> Product Change Notification (PCN)

Product group:	SEMIPACK	Rev.:	0
No.:	PN20-003	Alternative supplier for nickel plated main terminals of SEMIPACK2	07 Feb 2020

Subject of change: Nickel plated main terminals of SEMIPACK2

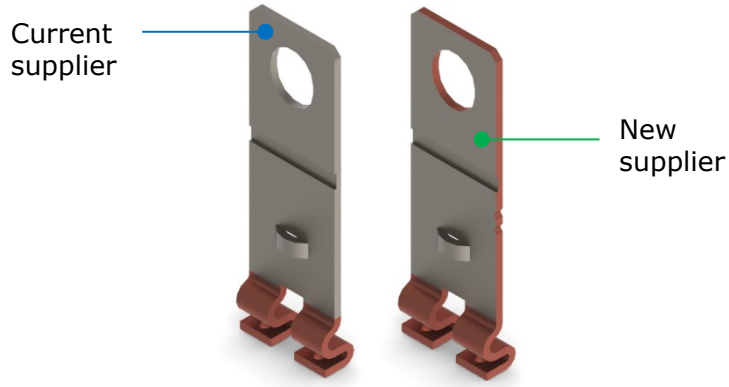
Description of change: Introduction of an alternative supplier for the main terminals. The material properties of the terminals remain unchanged. The Ni plating of terminals from the new supplier shows a different visual appearance which is only a cosmetic optical deviation with no impact on any relevant terminal properties.

At new supplier, the terminals are stamped from galvanized copper plates, similar to e.g. terminals of SEMIPACK 1. In consequence of this process, the terminal edges exhibit bare copper. This modification has no impact on any relevant terminal property.
